## **Final Acceptance Punchlist**

### **El Paso County – Department of Public Works - Stormwater Section**

Project Name:	Falcon Marketplace
EDARP Filing Number(s):	SF191, CON204, ASB233
ESQCP Number:	ESQ209
Attendees:	DPW SW: Christina Prete, Ben Jones, Erica Rylander, Joshua Augustenborg DPW Development Services: Jeff Rice, Brad Walters, Gilbert LaForce Developer: Karen Levitt Ortiz, Doug McNeal, Kate Varnum, Chris Heilbrun
Date of Walk-through:	10-22-2024
Walk-through Number:	1st

**Photo 6:** Remove concrete debris and sediment from inlets throughout site.

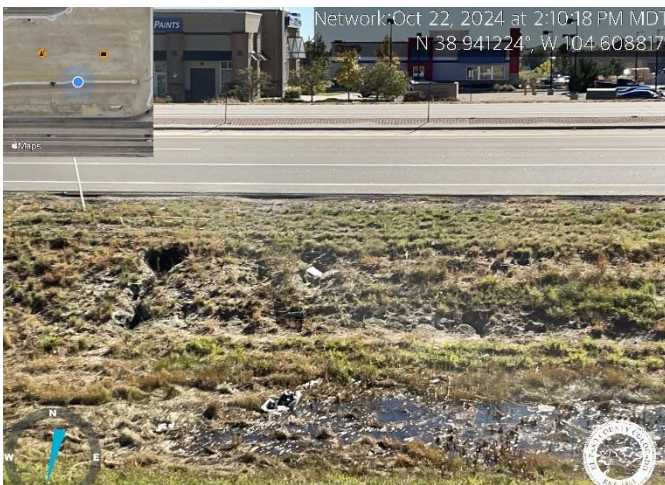
5. Repair minor erosion just upstream of culvert under roundabout entrance from Woodmen Rd (Photo 5).
6. Remove concrete debris and sediment from inlets throughout site (Photo 6).

**Photo 22:** Remove and properly dispose of sediment and debris from micropool (Pond 2).

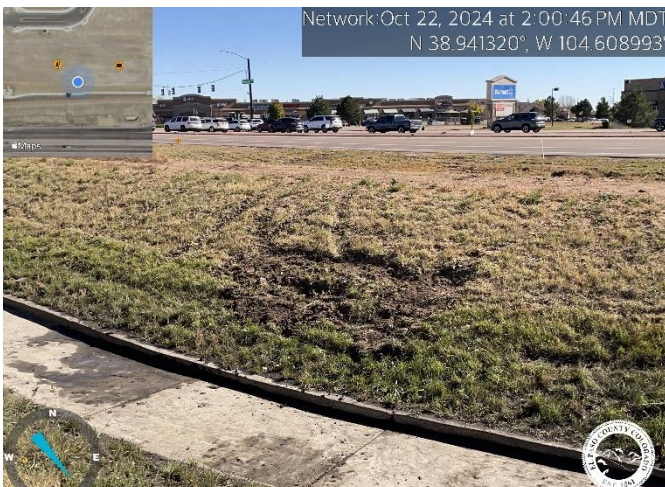
24. Remove and properly dispose of sediment and debris from micropool (Photo 22).
25. Repair disturbance on embankments/bottom of EDB from equipment accessing EDB for maintenance. Seed disturbed areas (Photos 23, 24).
26. Additional seeding needed in several areas along northern embankment to meet stabilization requirements (Photo 25).

**Photo 35:** Repair rill erosion on western embankment (Pond SR4).

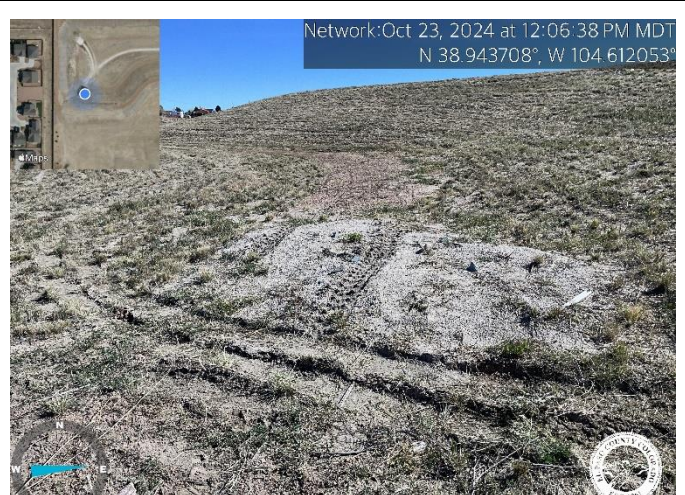
30. Repair rill erosion on western embankment (Photo 35).
31. Remove sediment accumulation within EDB micropool.
32. Remove sediment and reestablish maintenance access road to trickle channel east of outlet structure (Photo 36).

**Photo 42:** Repair disturbance from equipment accessing EDB for maintenance on northern and southern embankments. Reseed areas following repair (Pond SR4).

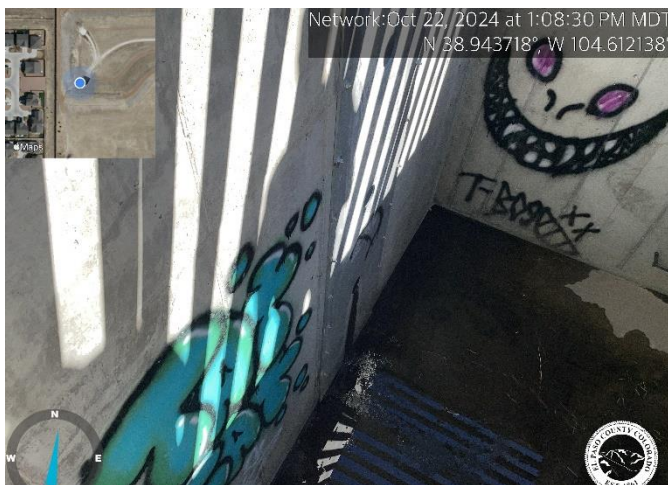
37. Repair disturbance from equipment accessing EDB for maintenance on northern and southern embankments. Reseed areas following repair (Photos 41 and 42).
